### NSLPP MEETING HELD ON 06/03/24

**ADDRESS:** 41 McLaren Street North Sydney

**APPLICATION No:** 269/23

**PROPOSAL:** Stage 2 of concept approval SSD-46014456, comprising fit-out of levels 3-7 and works on open terraces on levels 2, 3 and 6, to reuse the existing building as an independent K-12 school for up to 1,560 students.

**Play structure to level 2**

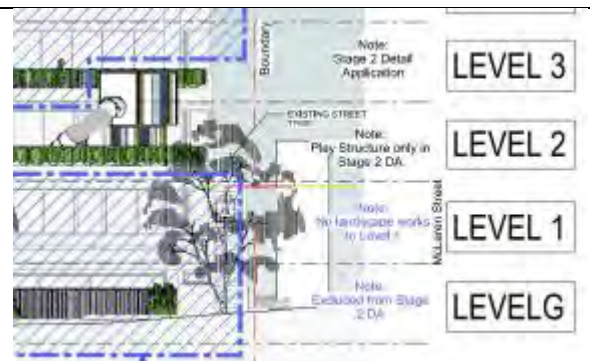
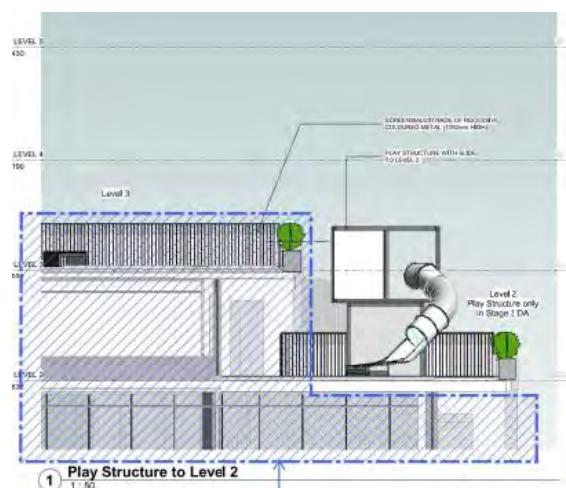
*The proposed lightweight vertical play structure was not part of the Stage 1 SSD application. It is proposed to be installed on the north-western corner of the level 2 terrace. Whilst it is described as being of a 'sculptural' form, and has the potential to be a reversible element, the lack of details relating to its materials, colour and finishes does not allow for a comprehensive assessment of its impact on the visual appearance of the subject building. As currently presented, the play structure has a height that is shown to be on par with the height of the horizontal landscaping along the level 3 terrace whereby partially obscuring the green banding effect across the level 3 terrace. It is recommended that the details of the materials, colour and finishes for the proposed light-weight vertical play structure be provided including a revision of its overall height to remain below the underside of the level 3 terrace to minimize its visual impact from the public domain.*

*It is noted that as part of the Stage 1 SSD process, discussions with Council took place in relation to the fence realignment on McLaren Street and the entry under-croft area on the ground level regarding the (re)installation of a sculpture to replace the lost sculpture took place. A condition recommending that the proposed DA is consistent with these discussions is recommended.*

- 1. Ensure the treatment of the fence realignment on McLaren Street and the entry under-croft area on the ground level are consistent with discussions held with Council regarding the (re)installation of a sculpture to replace the lost sculpture and ensure it satisfies Council's Public Art Policy and achieved in consultation with Council's Arts & Crafts Team Leader as part of the SSD approval. These discussions should continue, as enabled by condition D36 of the Stage 1 approval.*
- 2. That details of how the new installation of services infrastructure for the school use are to be undertaken so as to minimise impact on fabric. Condition B15 of the stage 1 approval requires appointment of a Heritage Architect, to advise on and oversee the design, contract documentation and construction of the works.*
